STATE OF NORTH CAROLINA
DEPARTMENT OF TRANSPORTATION

Addendum No. 1
RE: Contract # C204039
WBS # 34243.3.2
STATE FUNDED
Polk County (I-4729A)
I-26/US-74/NC-108 Interchange Modifications in the Town Of Columbus

September 19, 2017 Letting

The following revisions have been made to the Roadway plans:

17-AUG-2017 10:15
J:\1-4729A\Roadway\XSC\1-4729A_Rdy_xpl.dgn
$$$$USERNAME$$$$

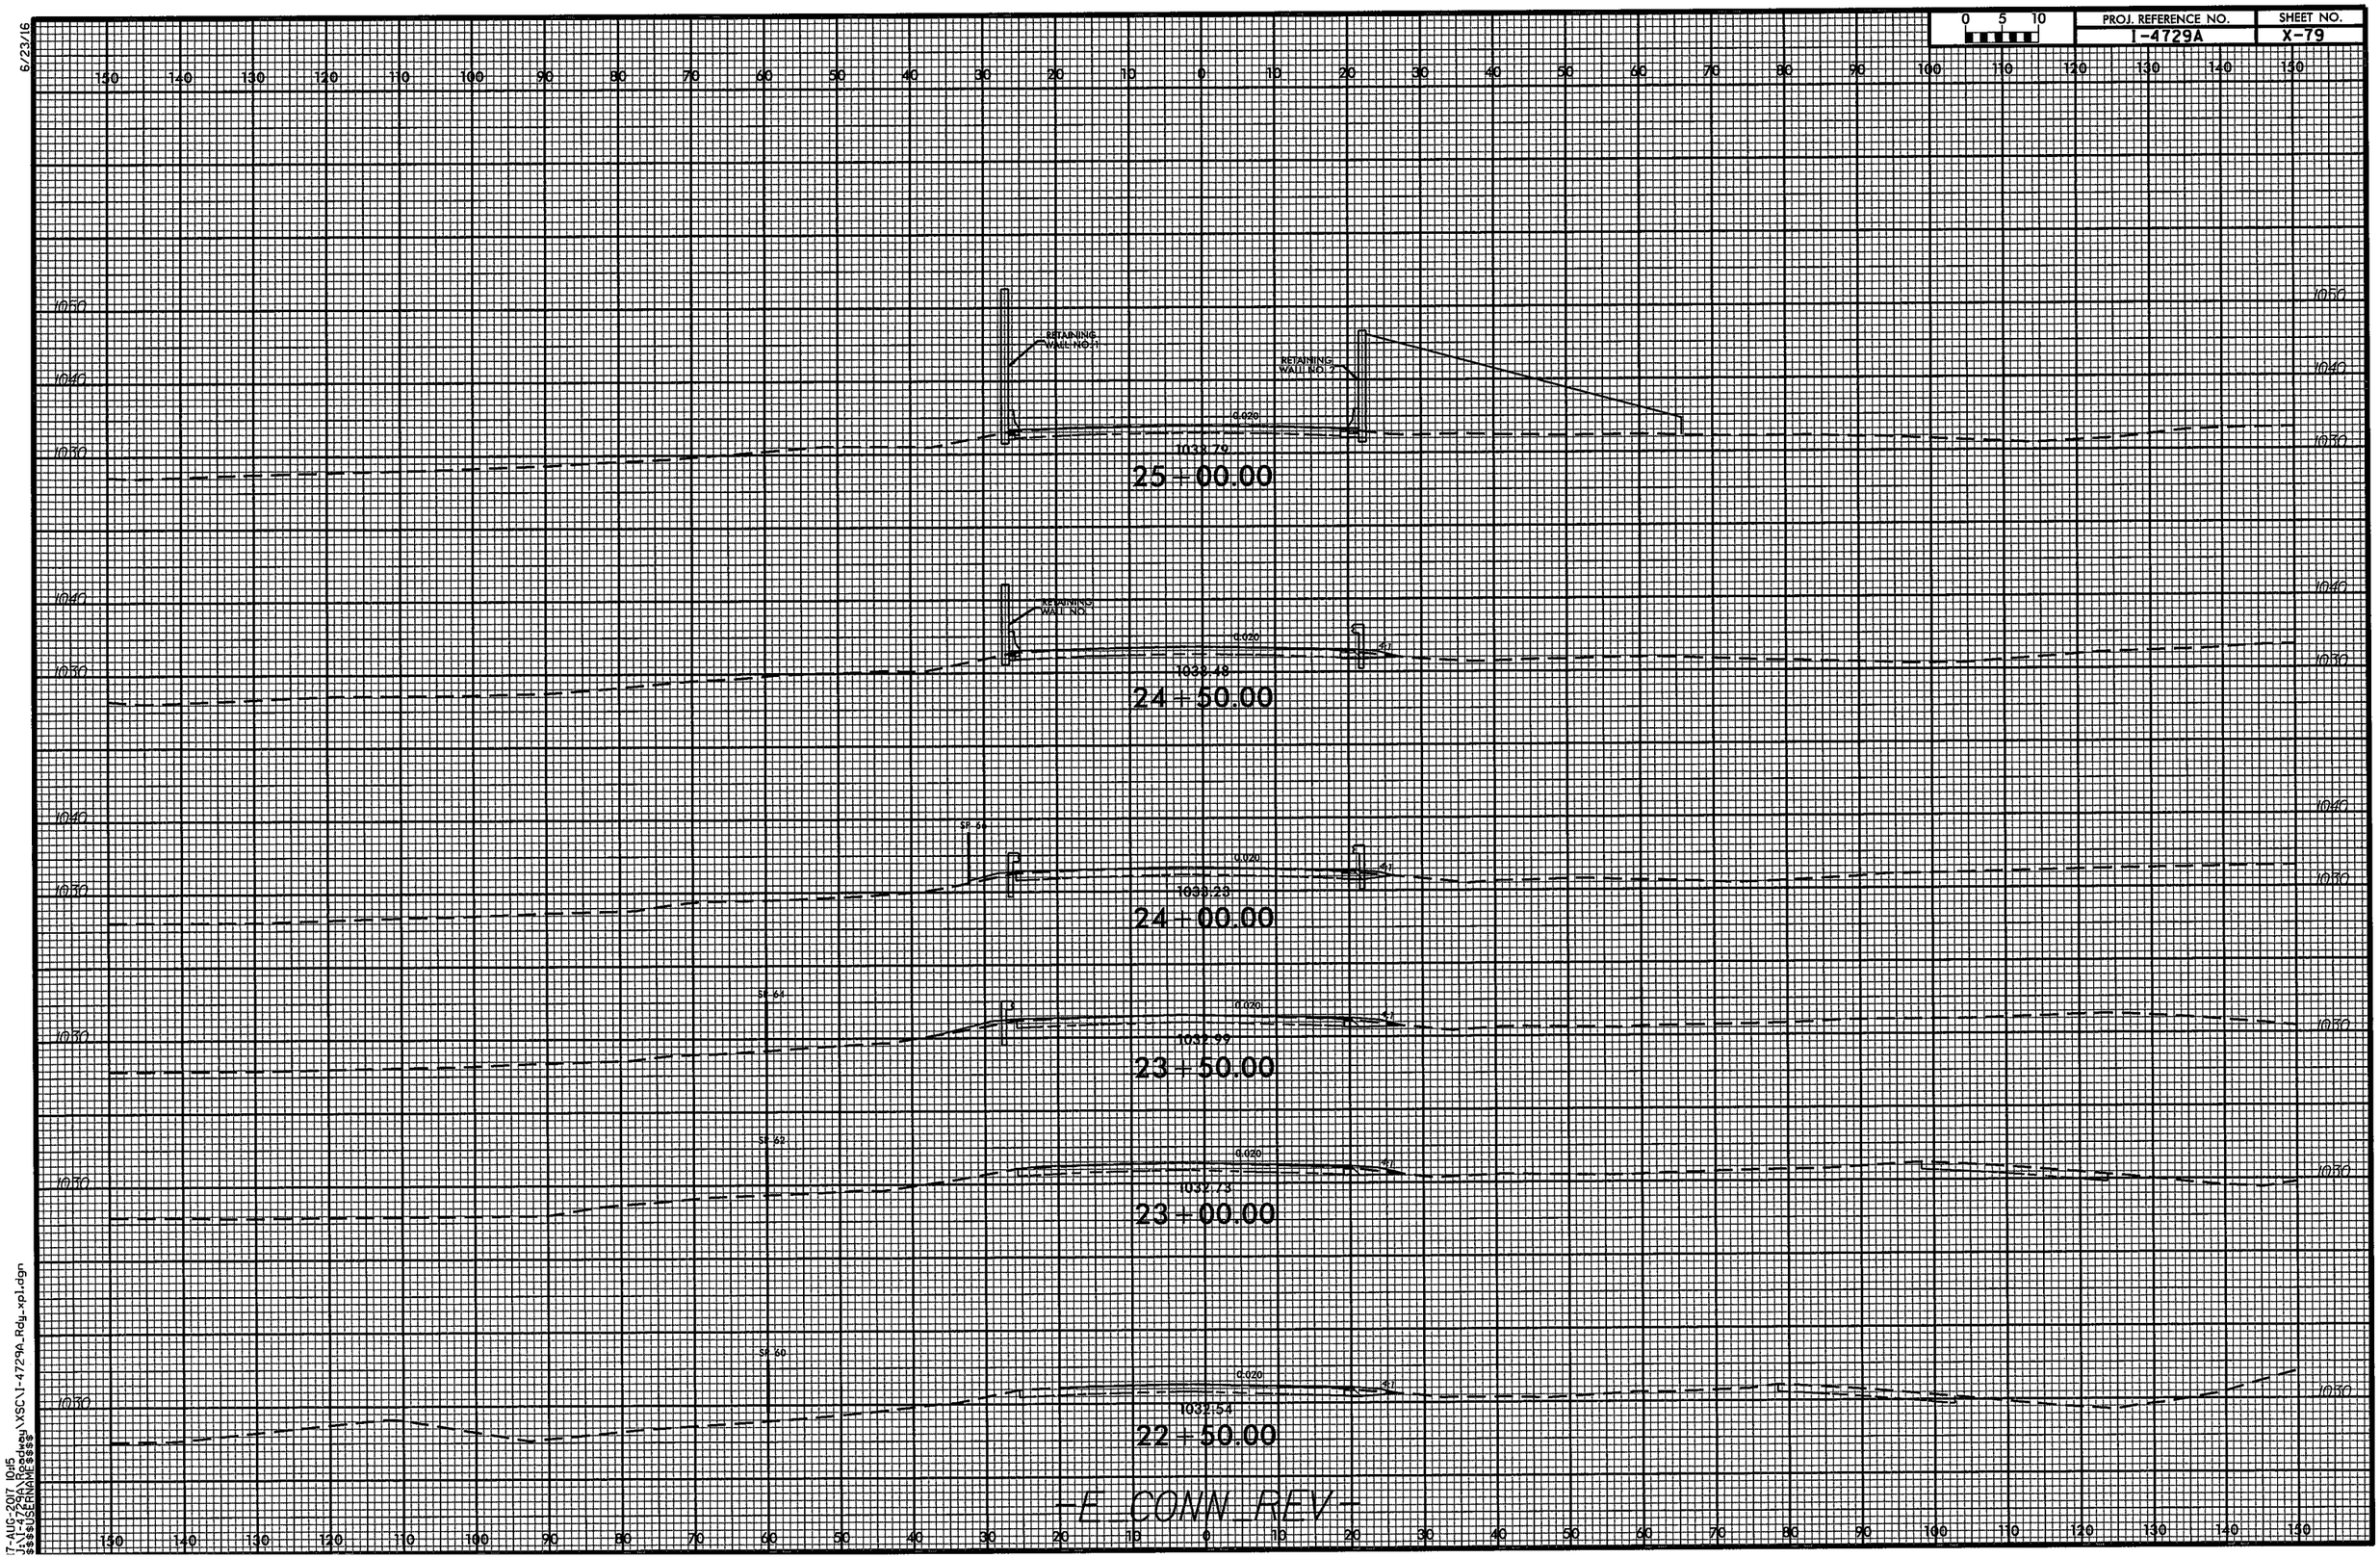
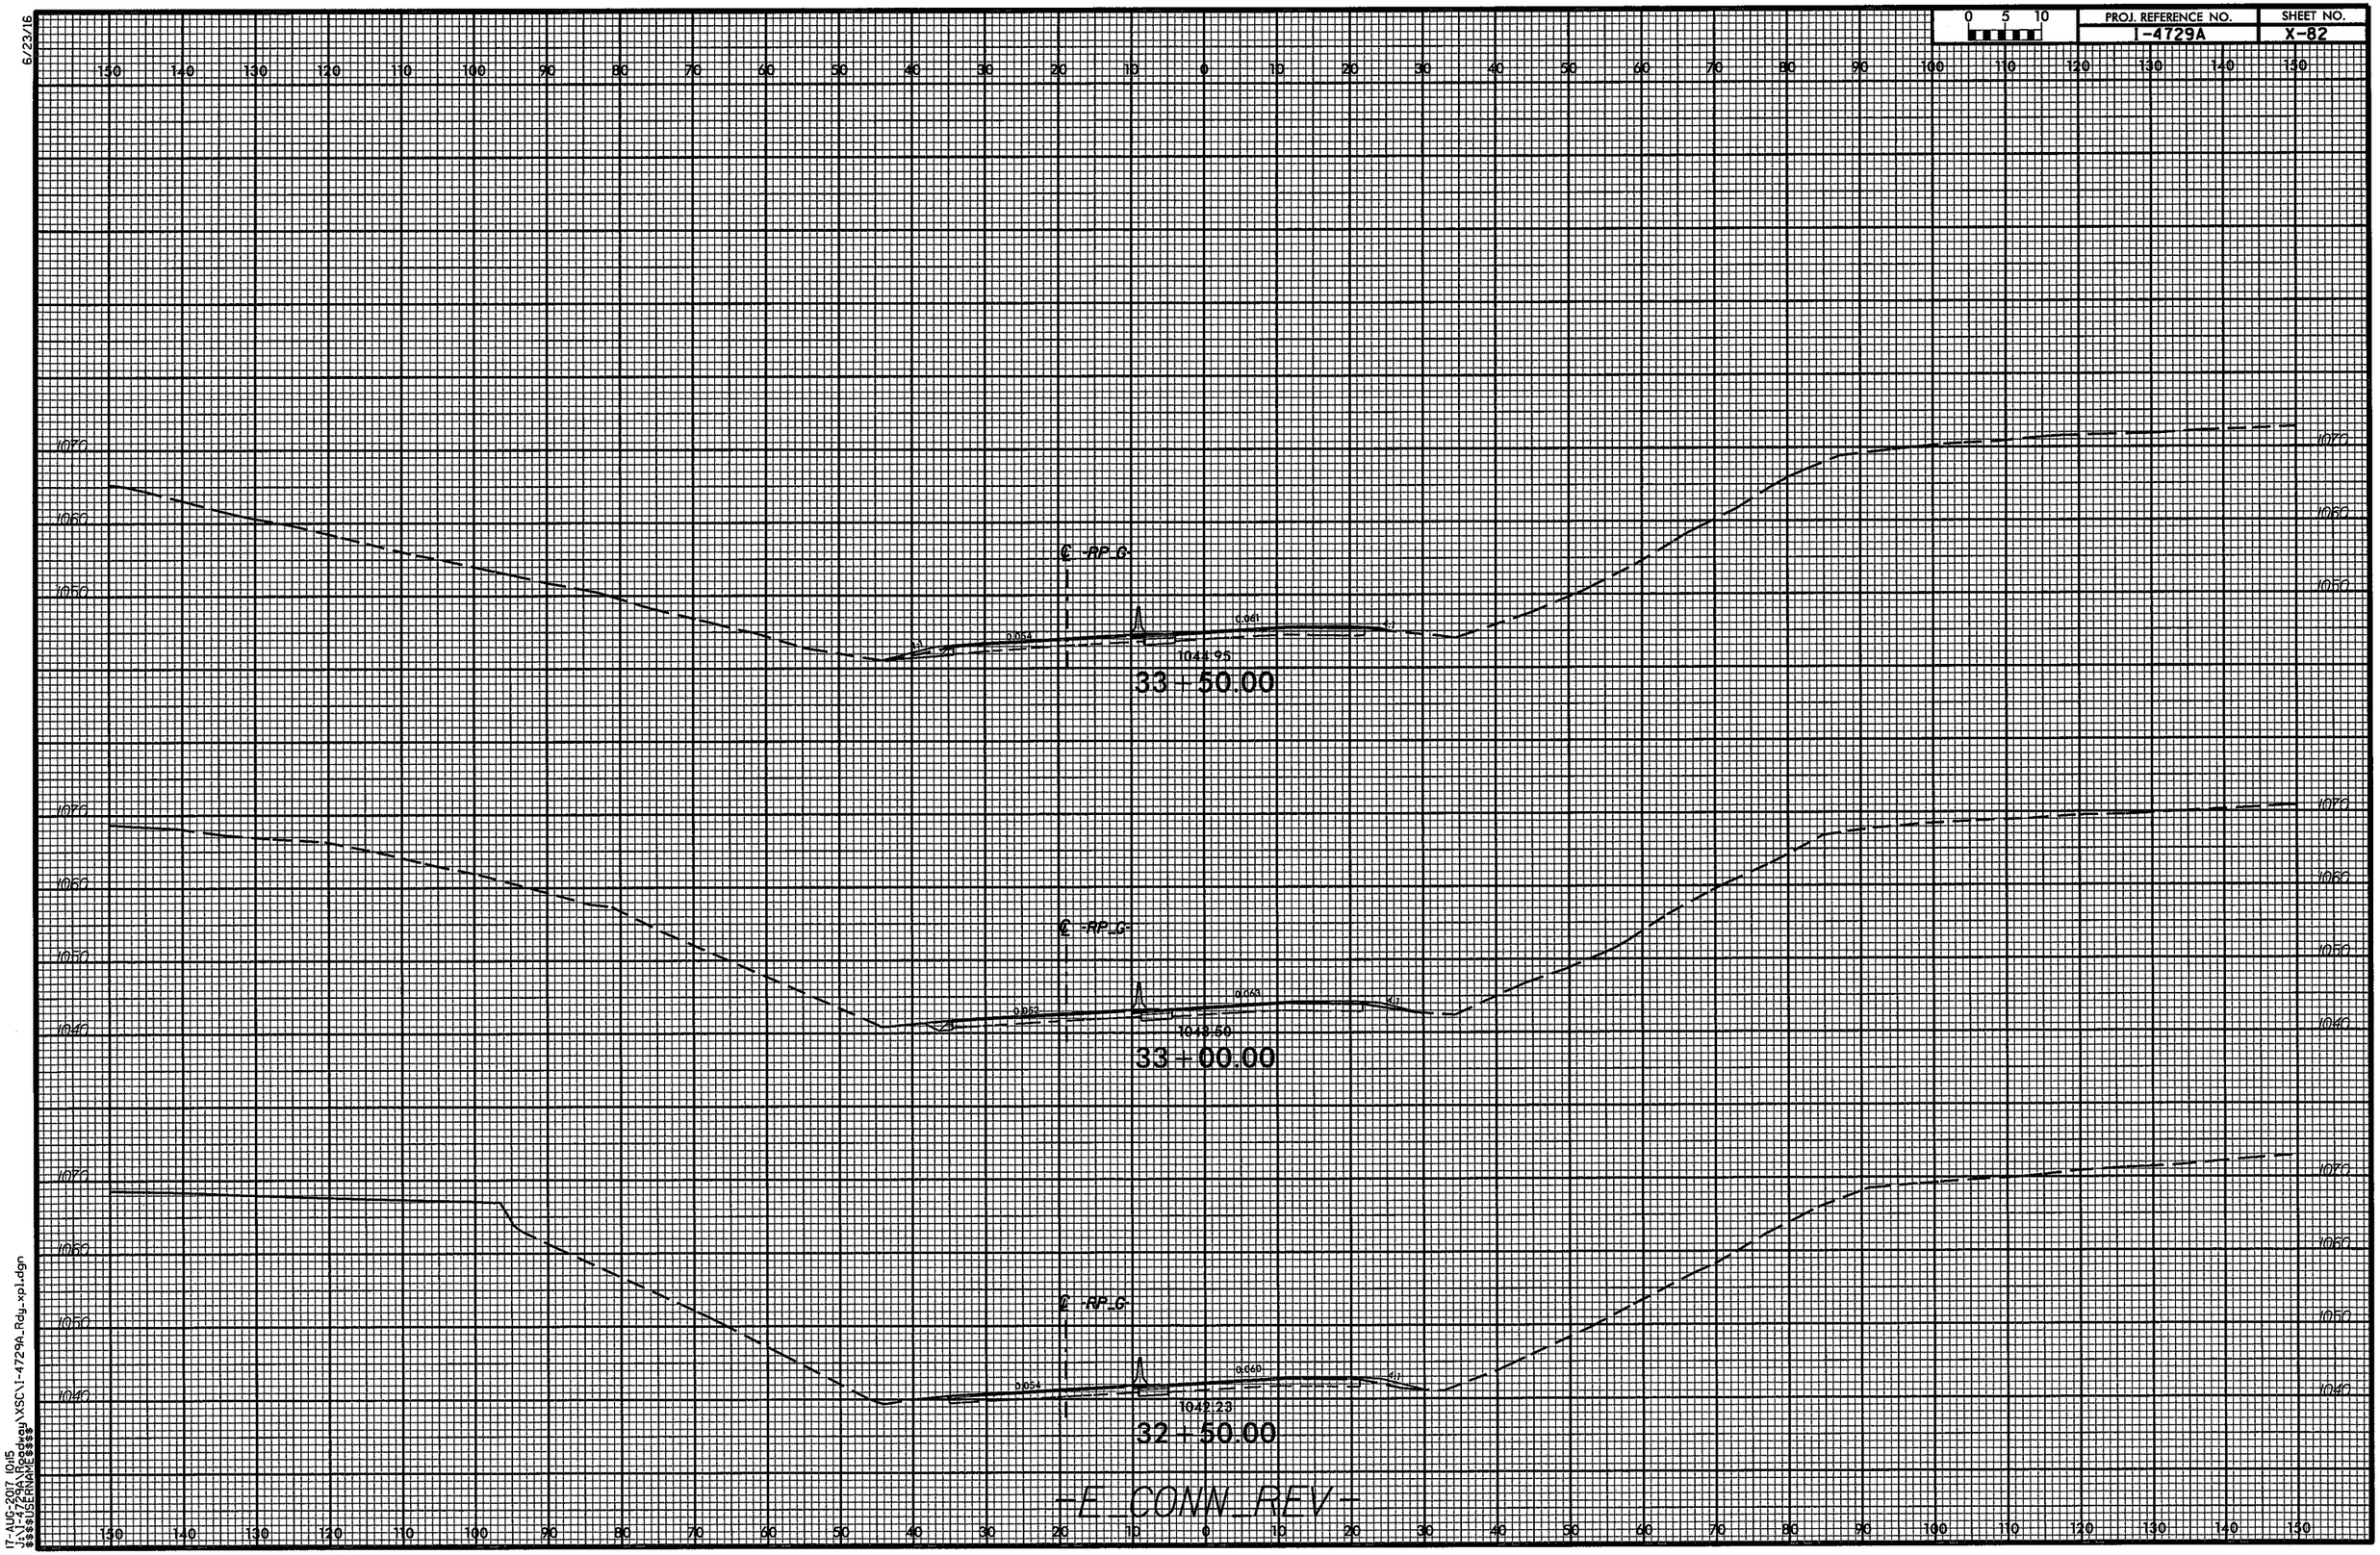
Sheet No.	Revisions
1A	Revised Index of Sheets to remove 2G-2 "Standard Embankment Monitoring Detail" and revise the number of" Drainage Summaries" sheets
2A-1, 2A-4 and 2A-5	Revised the Typical Sections for the change in mainline pavement widening design from ABC to Asphalt Base
3B-1	Revised 'Summary of Earthwork' to account for pavement widening design change
3D-1 thru 3D-4	Various drainage quantity changes as noted below
3G-1	Removed "Settlement Gauge Summary" and added note that Bridge Waiting Period only applies to Approach Slab construction
5	Revised to require Welded Steel Pipe by Trenchless method under the Interstate 26
X-1A thru X-87	Revised Cross-Sections to reflect the change in Earthwork due to the pavement design change
